Town of Hilton Head Island Regular Design Review Board Meeting

Tuesday, February 28, 2012

AGENDA

DESIGN TEAM/DRB COMMENT SHEET

FLOOR PLANS

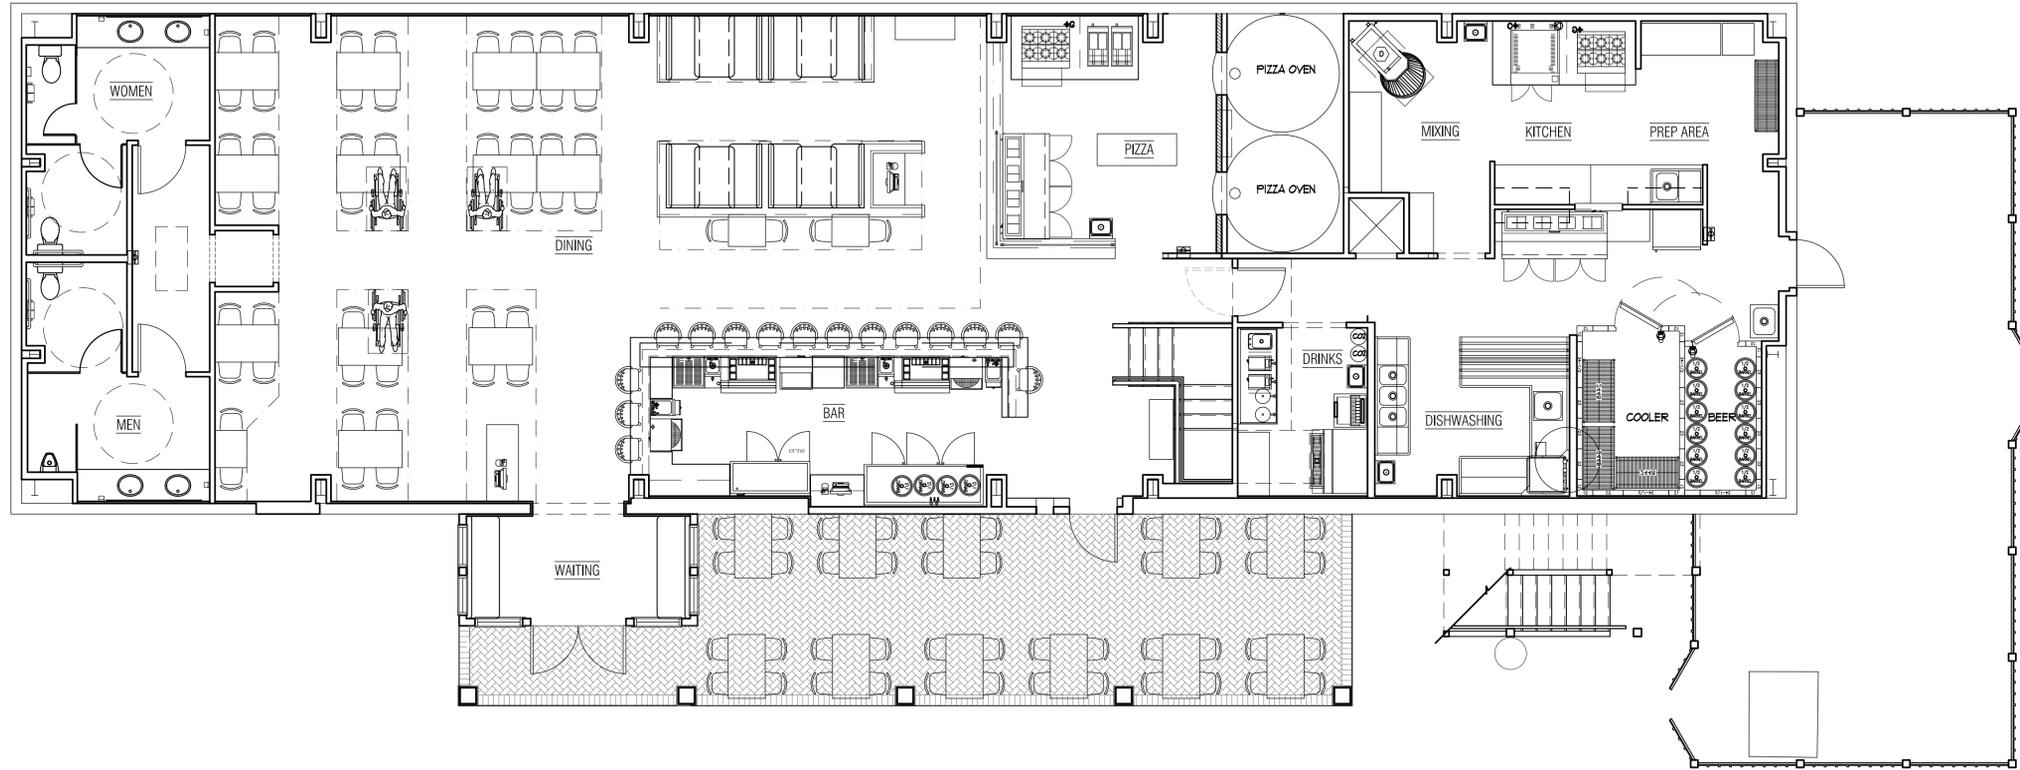
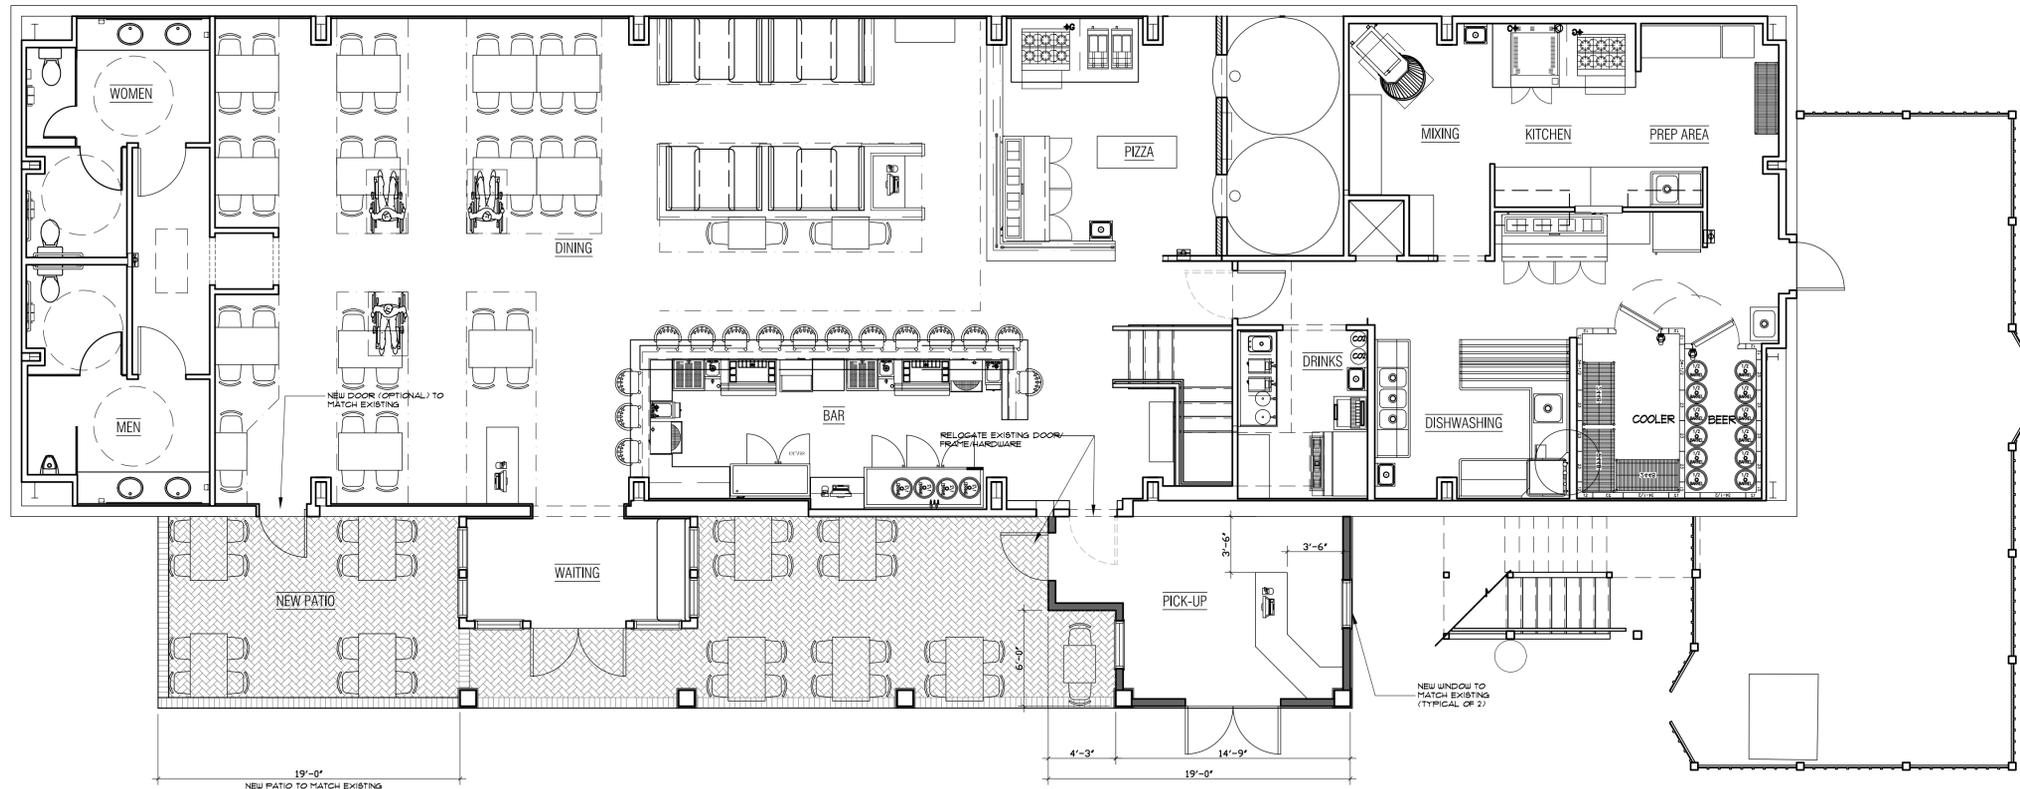
Project utilizes some of the existing covered outdoor patio as an enclosed space for carryout pickup and then reclaims the lost space with an expansion of the patio with uncovered seating. The materials, details, finishes, etc. all match the existing redevelopment effort. The through section would indicate the current column-turned pilaster would have no depth relative to the wall, and maybe the overall integration and geometry of the two existing columns should be addressed.
